ADDENDUM NO. 2

Date: March 5, 2024
Project Name: M19 2024 Hangar Construction
Owner: City of Newport
Garver Project No. 2300820

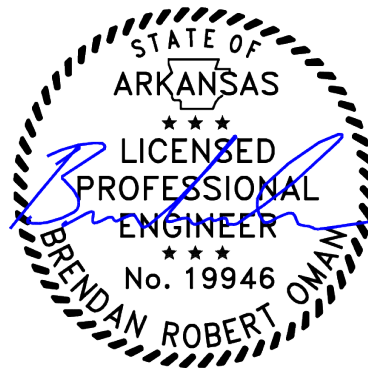
4. **Question:** The eave height will need to be increased to accommodate the hydraulic door. He is thinking he will be around 23' or 24' at the eave.

Answer: See Note 1, Sheet CS-201. This is acceptable. The building dimensions may vary depending on door and building manufacturer.
